PLANNING COMMISSION
DATE: 9/8/14
AGENDA ITEM: 5C – BUSINESS ITEM
CASE # 2014-46

ITEM: Hunter's Crossing Final Plat
SUBMITTED BY: Kyle Klatt, Planning Director
REVIEWED BY: Nick Johnson, City Planner
Jack Griffin, City Engineer

Re: Hunters Crossing – Ryland Homes
Final Plat and Construction Plan Review

TYPICAL 100' ROW STREET SECTION
TYPICAL SECTION (N.T.S.)
SEE LAKE ELMO STANDARD DRAWING NO 801 & 805

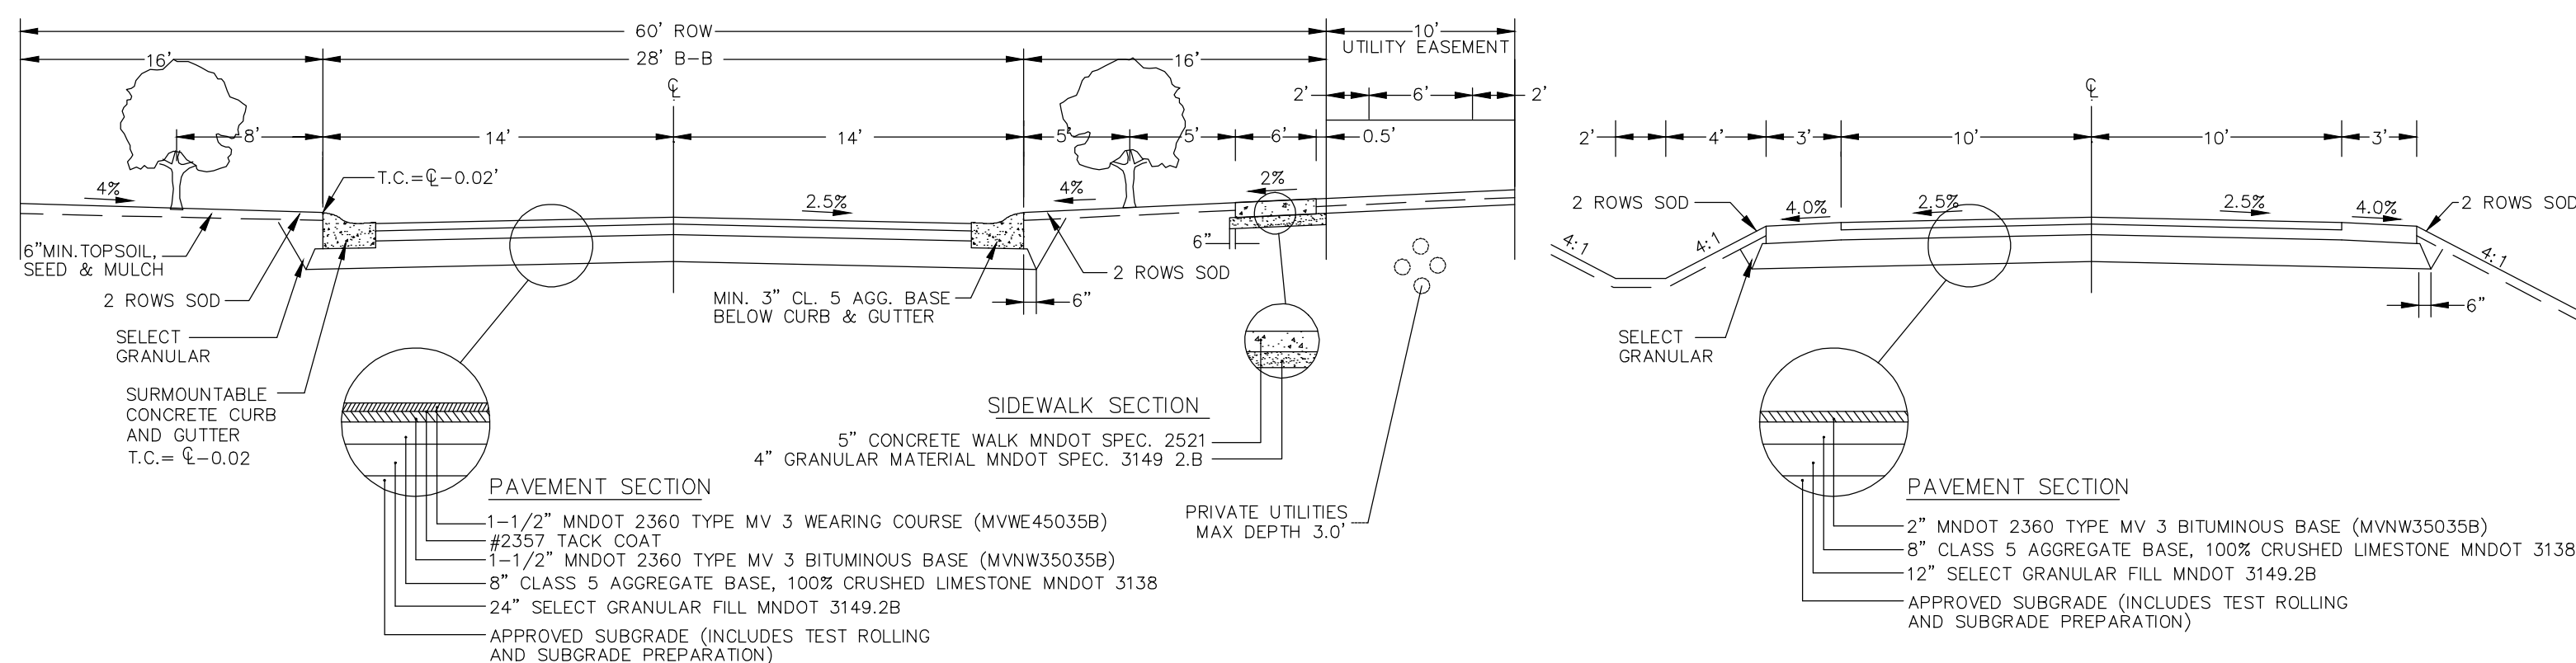
- Additional swale grade appears necessary along the rear property lines of Lots 1, 2 and 3, Block 4.
- The Grading Detail plan sheet must be updated to include the City Standard Typical Sections for 5th Street and Residential Streets and the custom typical sections removed to avoid conflicting section details.

- Replace the Typical 100-foot ROW Street Section on Sheet 16 with the City Standard Typical Section to remove all discrepancies from City Standards. Adjust all other plan documents as necessary to conform with the City typical section for 5th Street.

2 OF 23

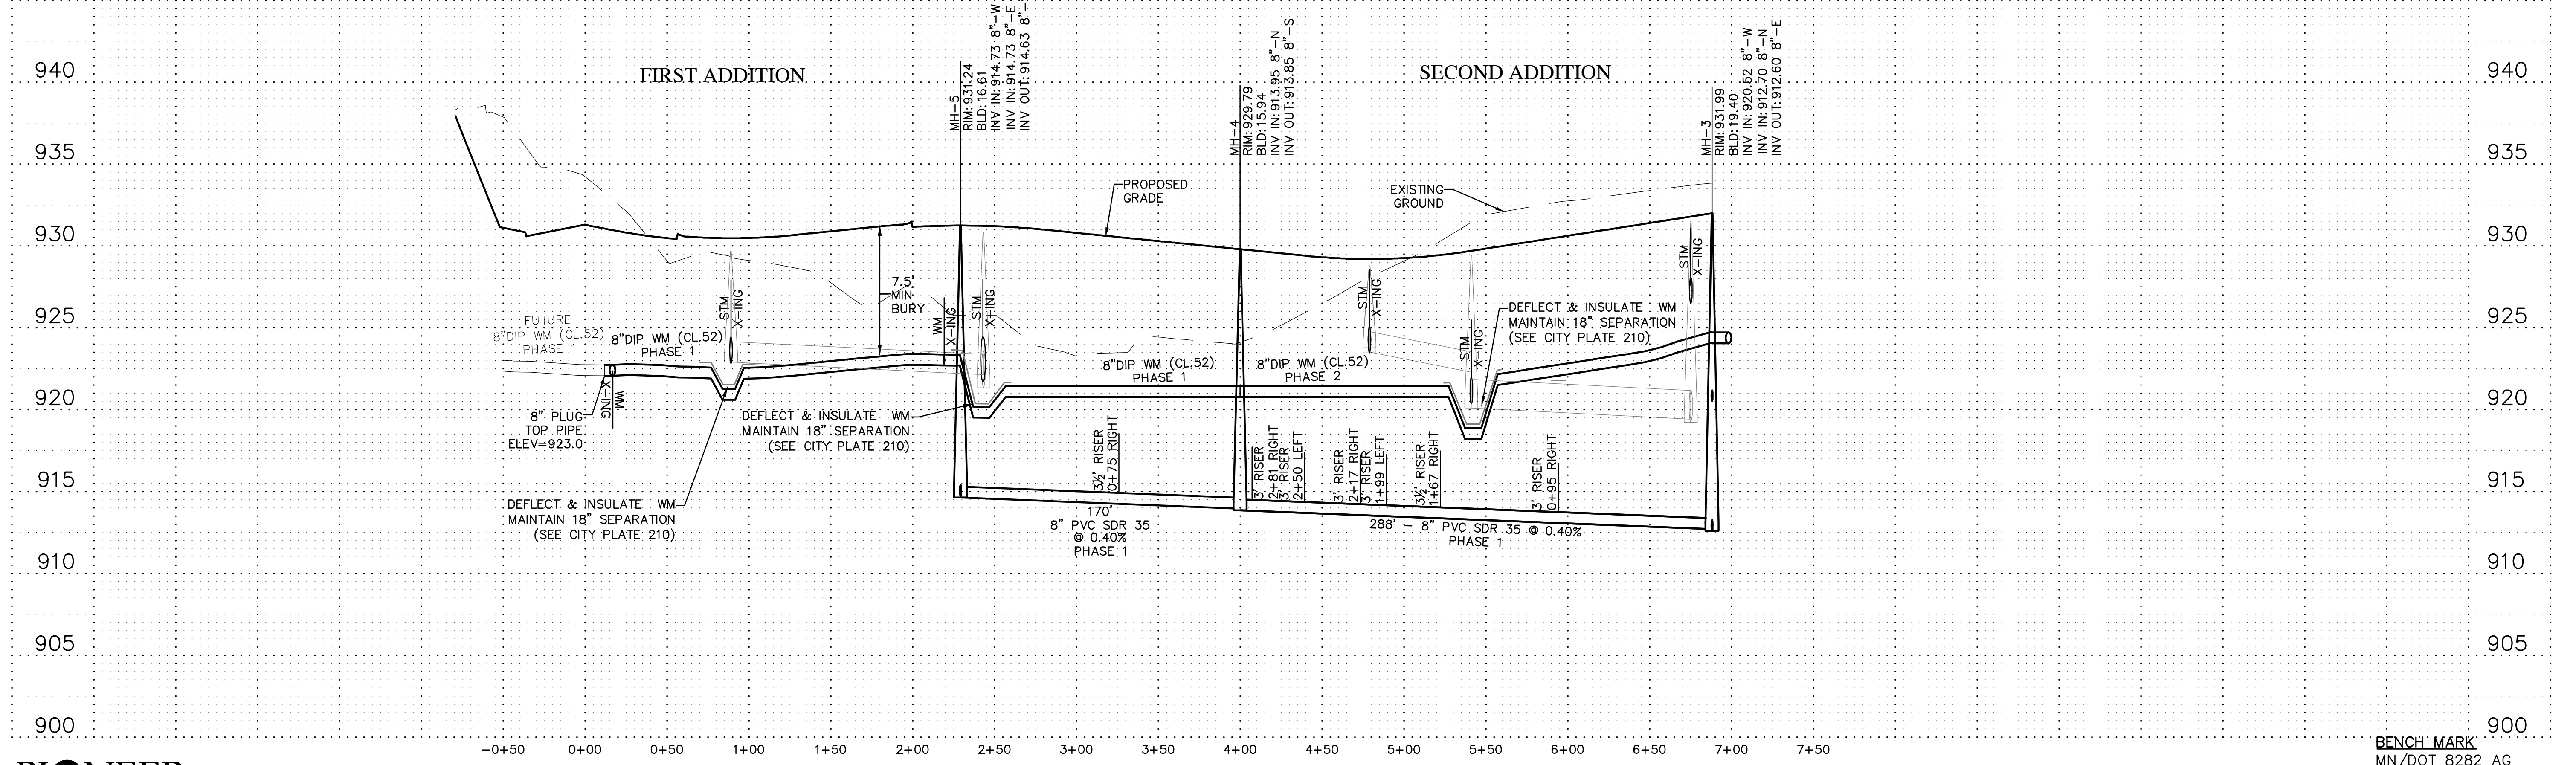
- The plans must be revised to better clarify between the Phase 1 and Phase 2 sanitary sewer and watermain. Add a temporary hydrant at each watermain end point for system maintenance.
- Replace the air bleed valve on Sheet 2 with a temporary hydrant on the watermain stub to the southern property line.
- Insert an 12" x 8" Tee fitting with a bend fitting on Sheet 2 along the 3rd Street watermain as the watermain turns south along the trail.

LANDSCAPE PLAN

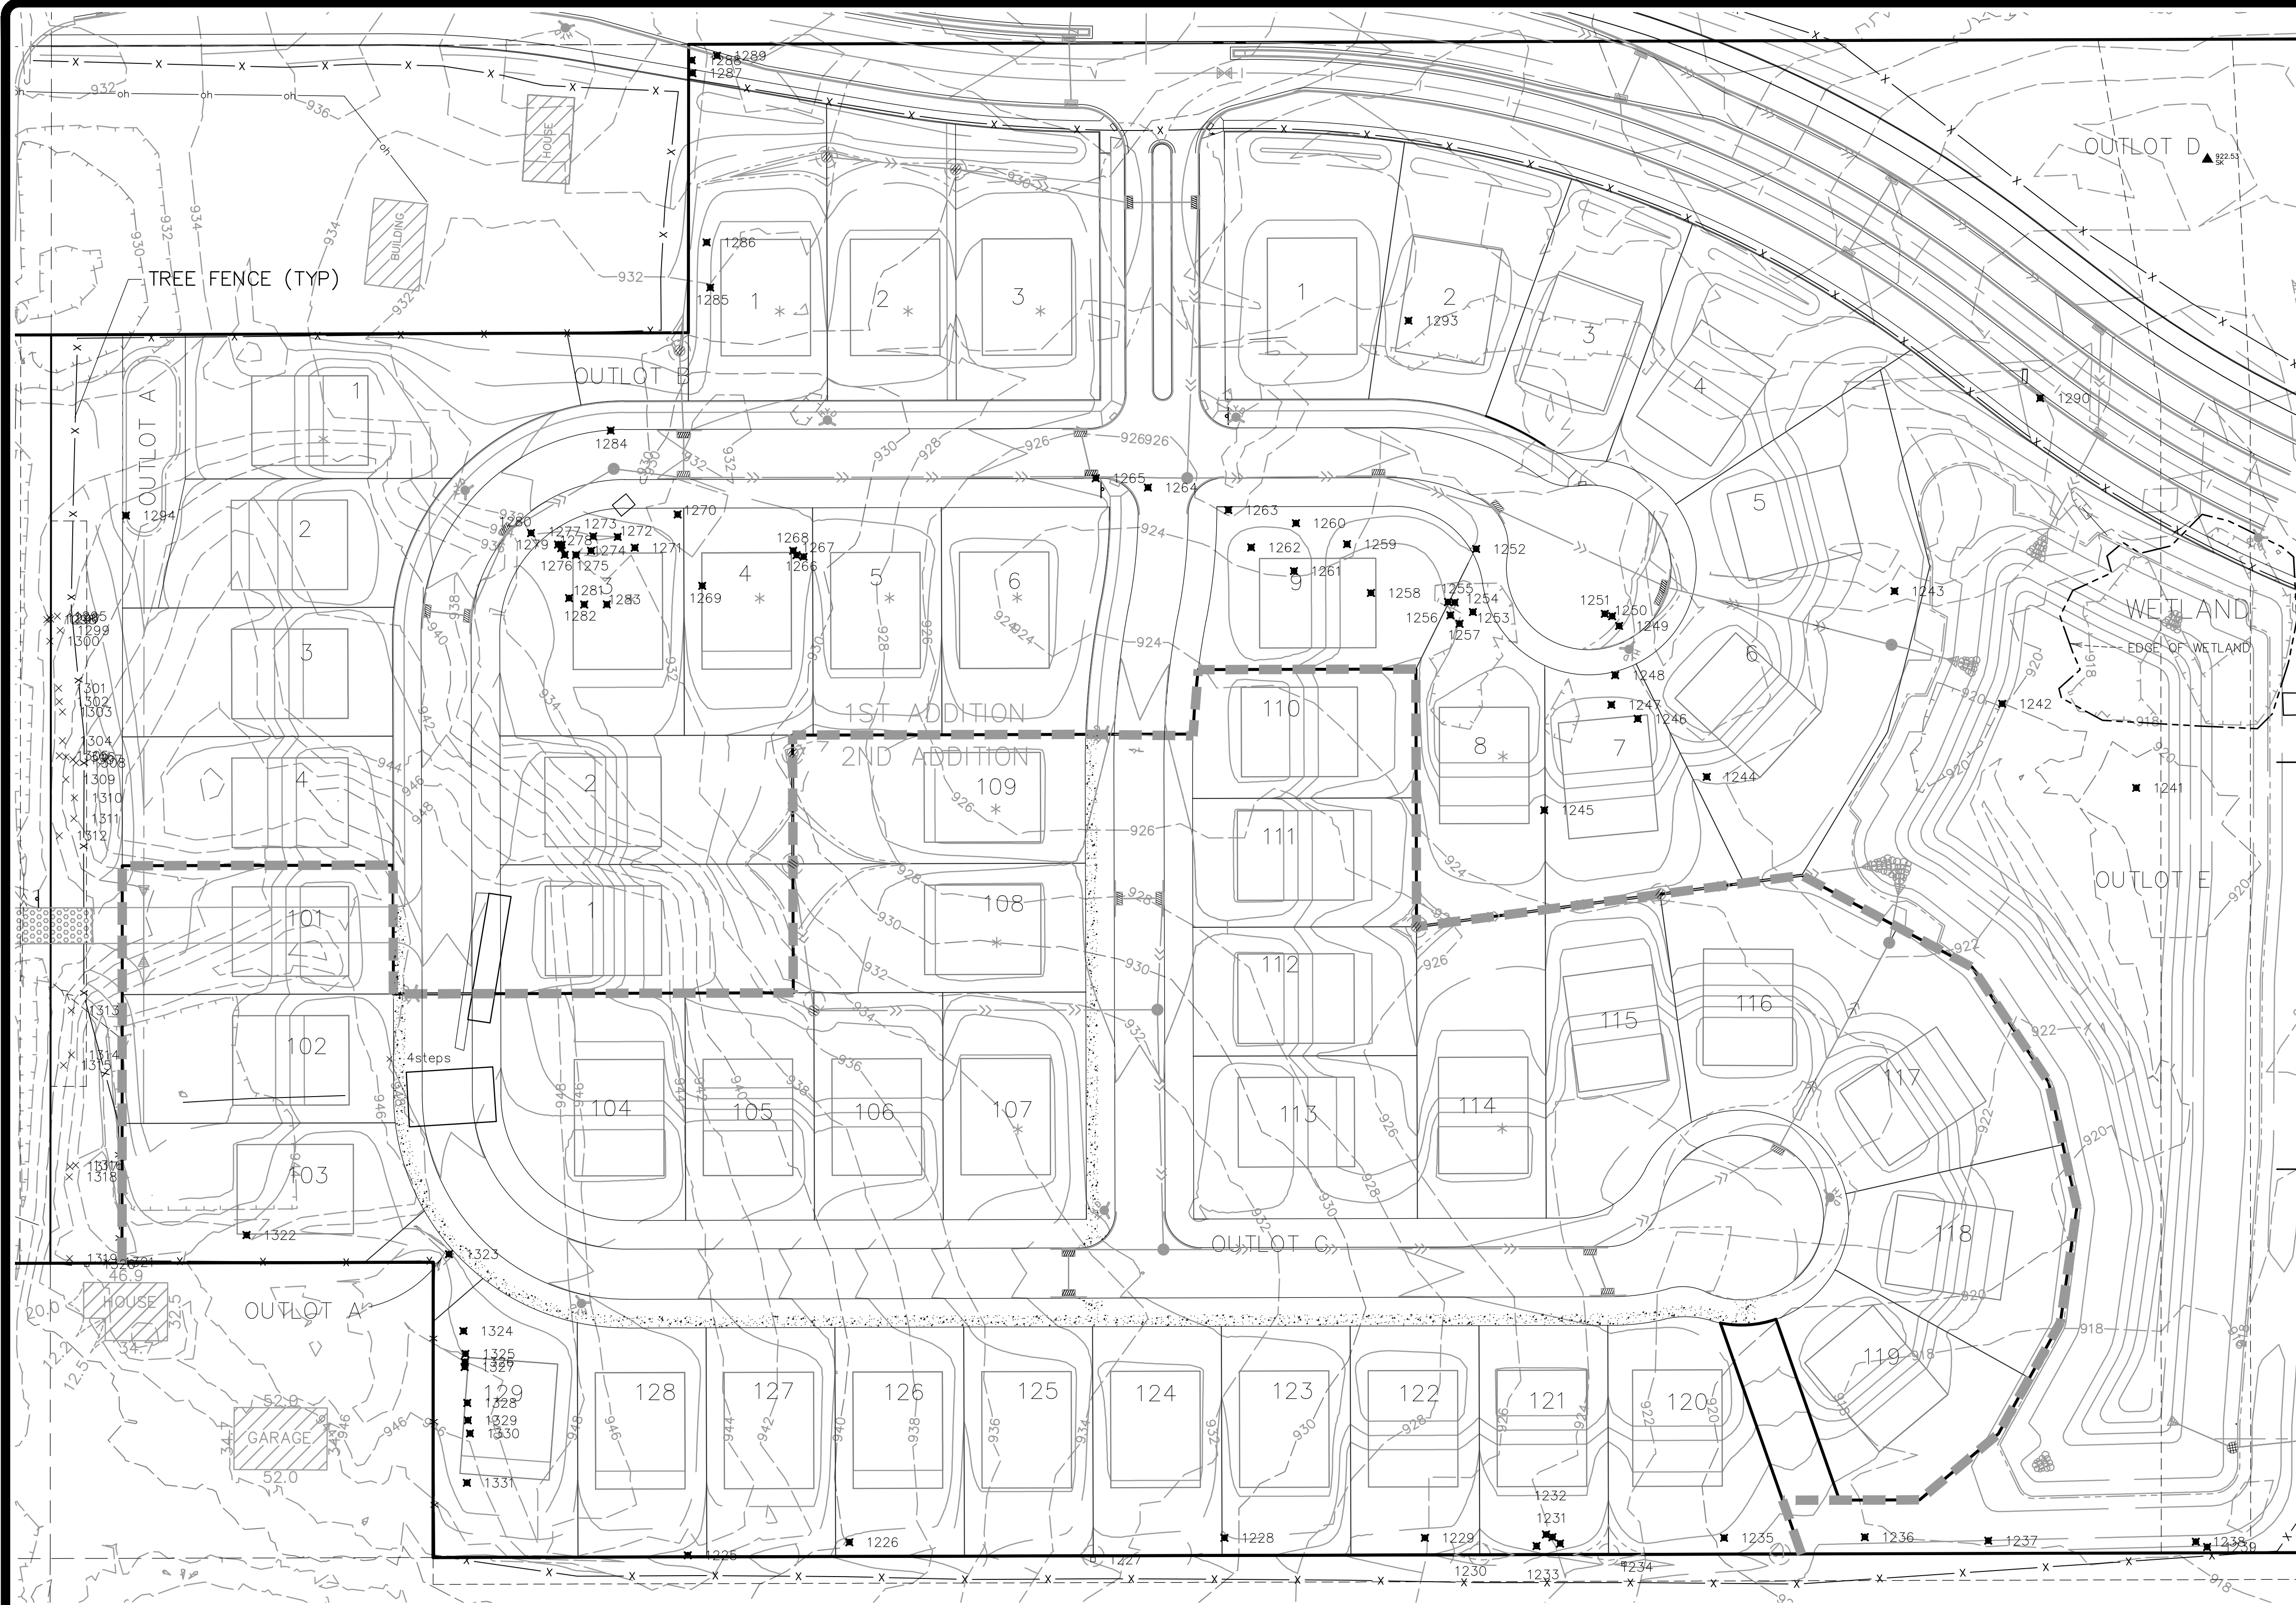
and his review is included as an attachment to this report. The applicant will need to further revise the landscape plan to comply with the City's landscape ordinance by either adding more trees or increasing the size of the proposed trees. Staff has found that the proposed plan is generally acceptable and complies with the City's expectations and requirements for street trees, and screening and buffering of adjacent properties. This is an issue that can be resolved through further discussions between the City and developer.

- 3) The final landscape plan shall incorporate additional planting where feasible adjacent to the shared property lines with the parcels at 404 and 275 Lake Elmo Avenue North. ***Comments: The final landscape plan includes additional plantings along the southwestern property boundary. The number of plantings along the northwestern property boundary is similar to the preliminary plat; however, the location of the future access in this location (Outlot B) limits the developer's ability to add substantially more plantings along this boundary.***

- 6) The final landscape plan shall be updated to address the comments from the City's consulting landscape architect in a review letter to the City dated 9/5/14.
